■ FRAME

Models with Independent Front Suspension

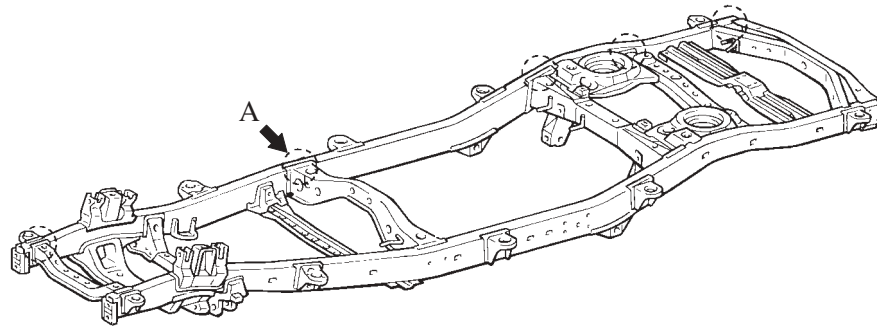
- The shape of the various areas of the frame has been modified in order to realize excellent collision safety performance, good driving stability and riding comfort.
- A continuous flange type construction has been adopted in the areas that join the side rails to the cross members to realize excellent joining rigidity. Similarly, the continuous flange type construction has been adopted in the areas that join the brackets.
